PREVOST

WARRANTY BULLETIN

WB16-02E

DATE :	MAY 2016	SECTION :	06 - Electrical
EXPIRATION:	MAY 2018		
SUBJECT :	CHARGING SYSTEM IMPROVEMENT

FIGURE 8

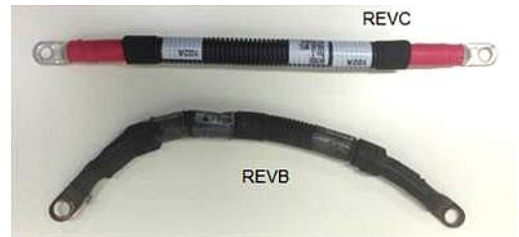
6. Reinstall the jumper cable **#067835 revision C** included in kit #7770176 (FIGURE 6, FIGURE 7).

Rev.C lug terminal through hole dia.= 5/16" **CORRECT**

Rev.B lug terminal through hole dia.= 13/32" **INCORRECT**

Rev.B diameter of the through hole is too large, reducing contact surface with the stud and the nut thus reducing electrical conductivity between the lug and the alternator stud (FIGURE 8).

FIGURE 9

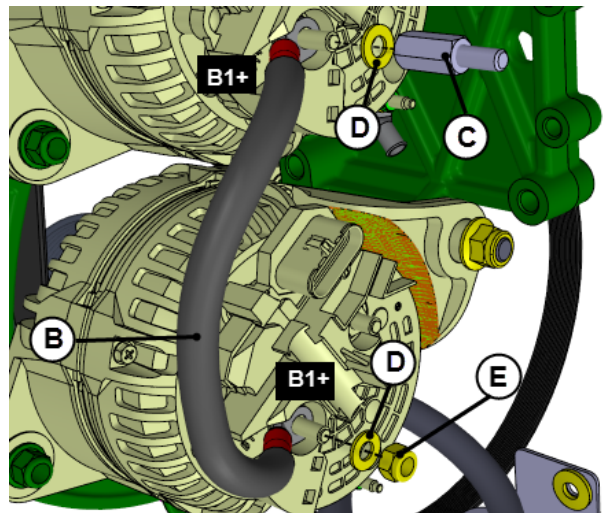
7. Reinstall appropriate jumper cable **B** (i.e. rev.C) with appropriate stud adapter. Refer to FIGURE 9.

B : JUMPER CABLE #067835 revision C

C : STUD ADAPTER #060297 torque: 10 lbf-ft

D: FLAT WASHER #5001341

E: NUT M8 #5001787 torque: 10 lbf-ft

FIGURE 10

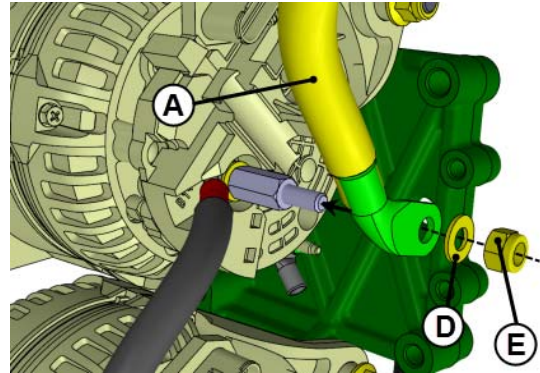
-
8. Reinstall power cable **A**. To do so, connect power cable **A** to the upper alternator **B1+** stud terminal. Refer to **FIGURE 10**.

A : POWER CABLE

D: FLAT WASHER #5001341

E: NUT M8 #5001787 *torque: 10 lbf-ft*

FIGURE 11 : VECR

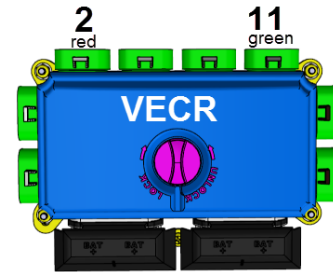
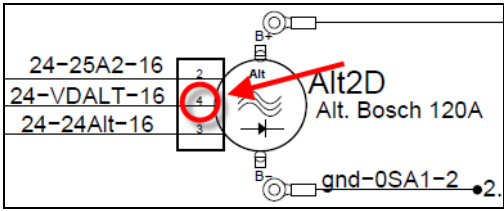
2.2 ALTERNATOR 24VD (DIRECT) ON PIN #4 CHANGED FOR 24VI (INDIRECT)
NOTE: this corrective measure may have already been performed on your vehicle

1. Inside rear electrical compartment (rear junction box), locate VECR module (FIGURE 11).

FIGURE 12

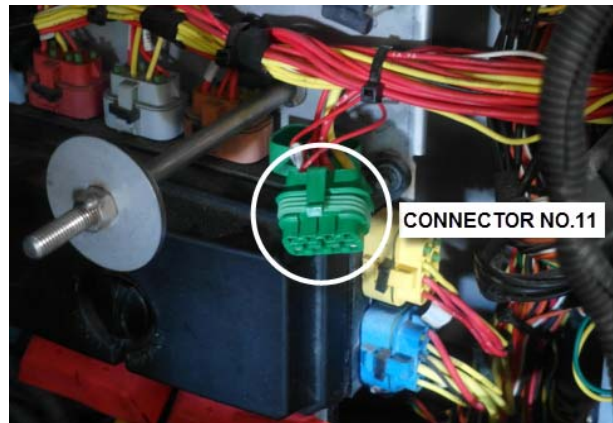
3. Using an extractor tool or a small flat blade screwdriver, remove wire 24VDALT from cavity H of connector no.11 (FIGURE 12 to FIGURE 15).

FIGURE 17 : WIRING DIAGRAM PAGE 5.1

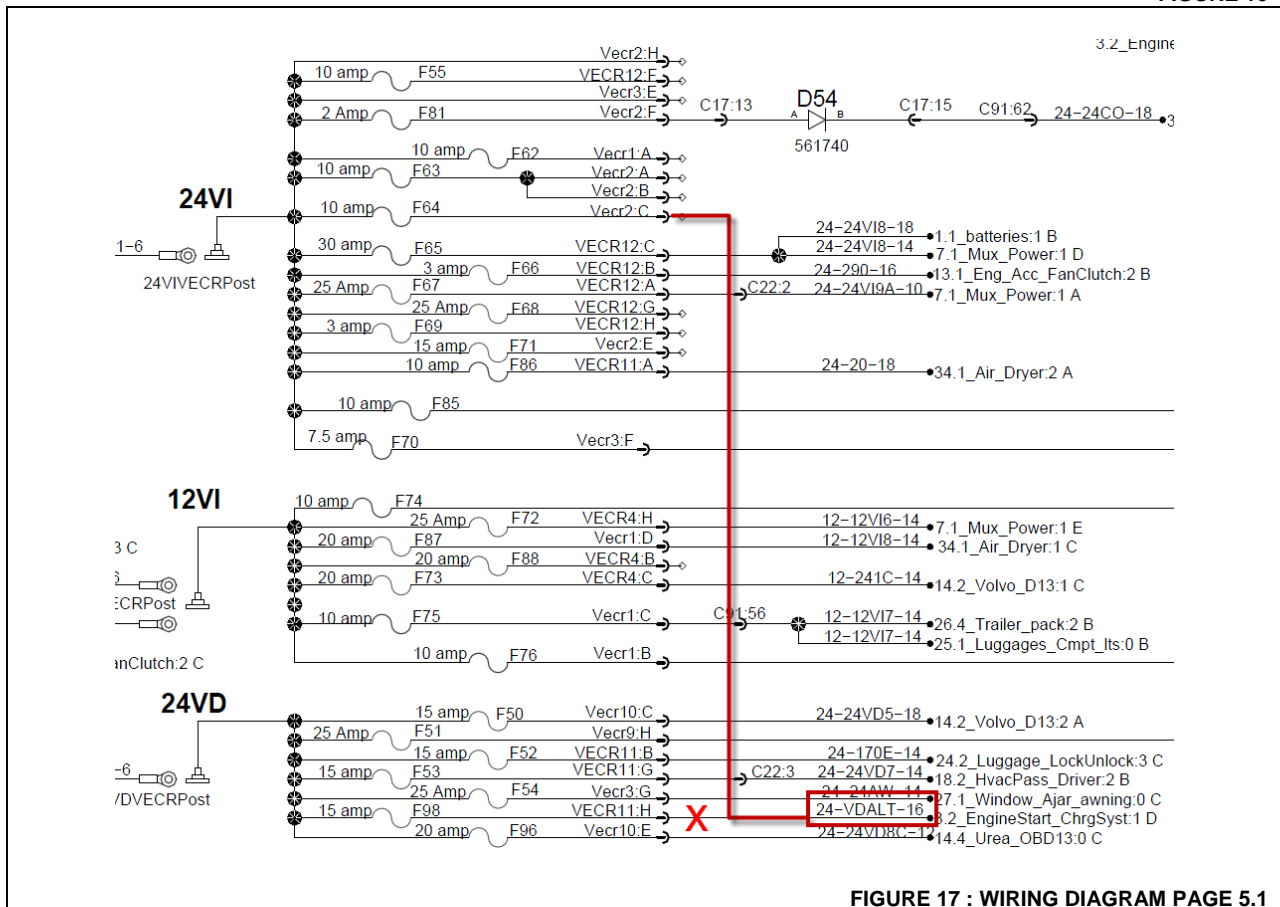
4. Relocate wire 24VDALT to cavity **C** of connector no.2 (red) on the harness.

Cavity **C** of connector no.2 should be available. This branch of the circuit will be protected by 10A fuse F64 (see FIGURE 17 below).

Should cavity C not be available, refer to your vehicle wiring diagram page 5.1 to select another free cavity protected by a 10A or 15A fuse (see FIGURE 17 for reference).
